## ADDENDUM NO. 2

TO: ALL BIDDERS  
PROJECT: ITB PW 75-19 – JAMES LEE PARK PARKING LOT IMPROVEMENTS  
BID TIME AND DATE: 3:15 PM LOCAL TIME, September 25, 2019 (NO CHANGE)

September 17, 2019

**SHEET NUMBER**  
**C-10**

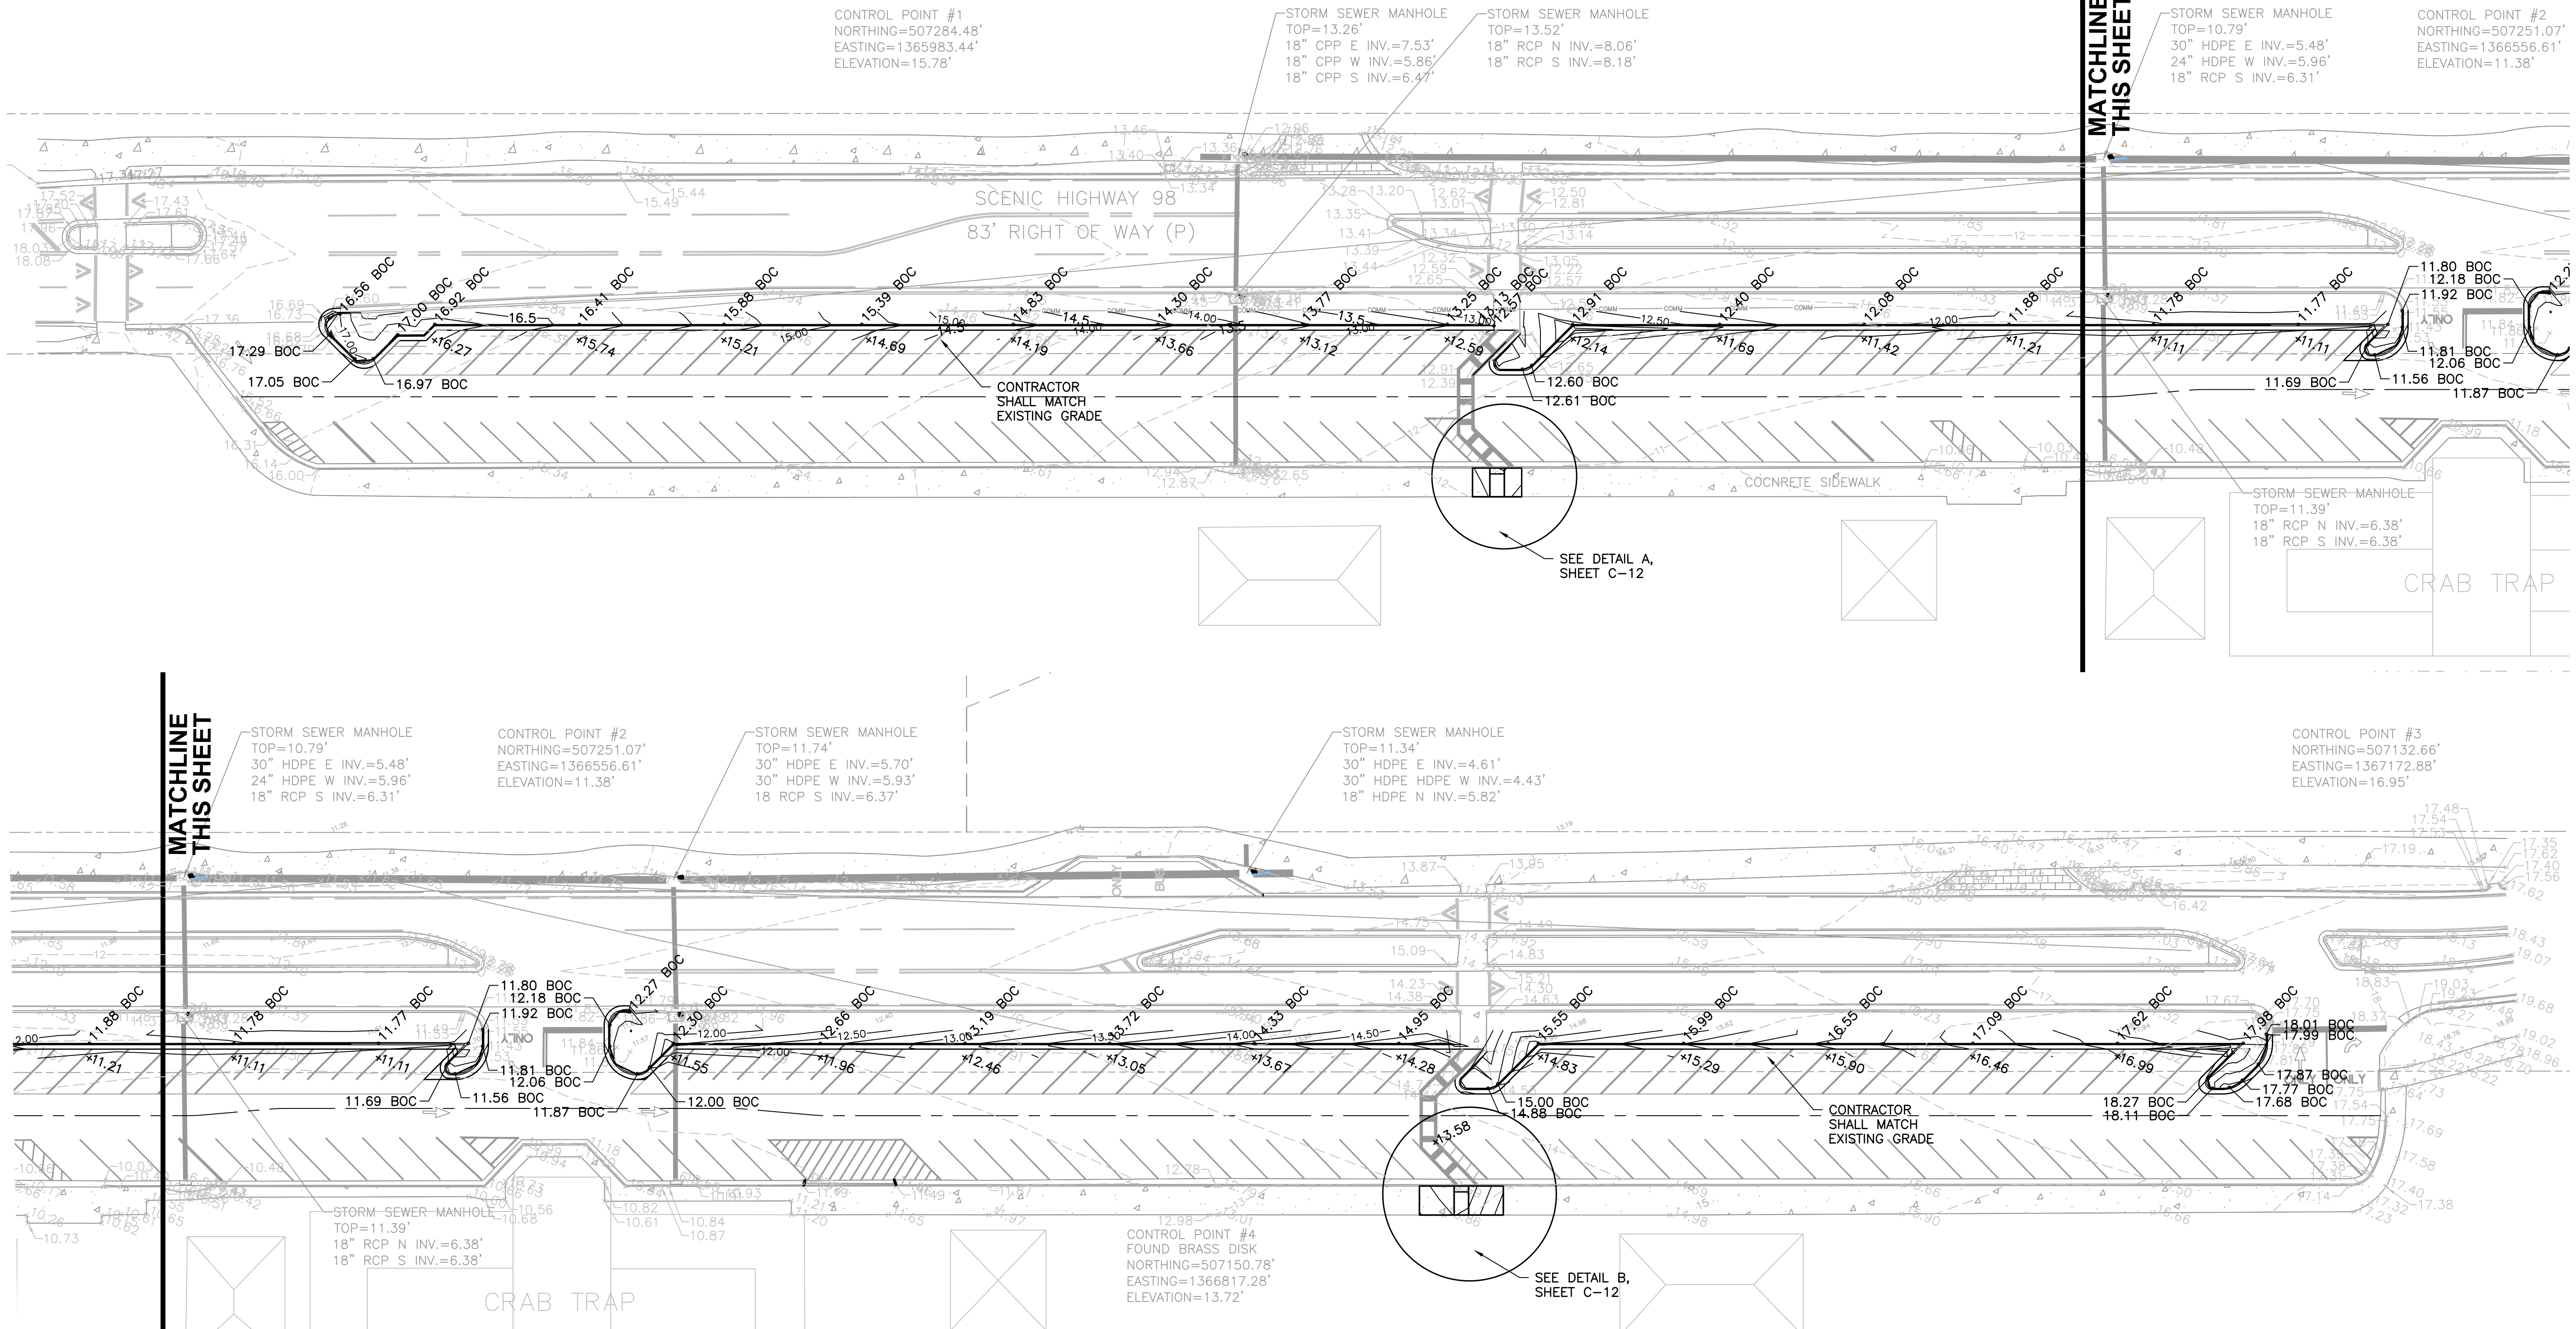
The following project drawings are revised: Sheet Numbers C-3, C-10 and C-11. Copies of the revised drawings are attached herewith and labeled as Addendum No. 2 in the upper left corner.

### SPECIFICATION SP-1-1 IRRIGATION WELL NOTES:

- CONTRACTOR TO FURNISH AND INSTALL ALL COMPONENTS FOR A COMPLETELY OPERATIONAL SHALLOW WELL AND IRRIGATION PUMP MEETING THE FOLLOWING MINIMUM REQUIREMENTS:

- 35 GPM AT 120 TOTAL HEAD IN FEET; 1-1/2 HP, 230V, 1PH
  - EQUAL TO STA-RITE HMS SERIES CAST IRON HORIZONTAL MULTI-STAGE CENTRIFUGAL PUMP OR APPROVED EQUAL. PUMP SHALL REST ON A SUITABLY SIZED CONCRETE BASE AND FITTED WITH A FIBERGLASS HOT BOX FOR FREEZE PROTECTION.

- CONTRACTOR WILL OBTAIN ALL LOCAL PERMITS TO COMPLETE THE WORK INCLUDING THE PERMIT FROM THE NORTHWEST FLORIDA WATER MANAGEMENT DISTRICT TO CONSTRUCT THE SHALLOW WELL. THE COST TO OBTAIN THE PERMITS SHALL BE INCLUDED IN THE LUMP SUM BID FOR THE IRRIGATION WELL.

- CONDUCTOR FOR WELL SHALL BE SIZED FOR THE RUN AND MAXIMUM LOAD; CONDUCTORS SHALL BE APPROVED FOR THE TYPE OF INSTALLATION. ALL CONDUCTORS SHALL BE CONDUIT.

- CONTRACTOR TO FURNISH AND INSTALL MOTOR STARTER, IRRIGATION CONTROLLER, AND RAIN SENSOR. THE LOCATION OF THE STARTER AND CONTROLLER SHALL BE AS SPECIFIED BY OWNER AT TIME OF INSTALLATION. CONTROLLER SHALL BE RAINBIRD ESP-ME3 SERIES (4 STATION); RAIN SENSOR SHALL BE RAINBIRD RSDBEX.

- CONTRACTOR TO LEAVE A MULE TAPE IN ALL INSTALLED CONDUIT FOR USE BY OTHERS.
  - ALL ELECTRICAL WORK SHALL MEET THE REQUIREMENTS OF APPLICABLE NEC AND LOCAL AND STATE BUILDING CODES.

- IRRIGATION PIPING, VALVES, AND SPRAY HEADS NOT IN CONTRACT.
  - THE LUMP SUM PAYMENT FOR THIS ITEM SHALL BE INCLUSIVE OF ALL LABOR, MATERIAL AND PERMITS FOR A COMPLETE AND OPERATIONAL SHALLOW WELL IRRIGATION PUMP UNDER PAY ITEM SP-1-1.
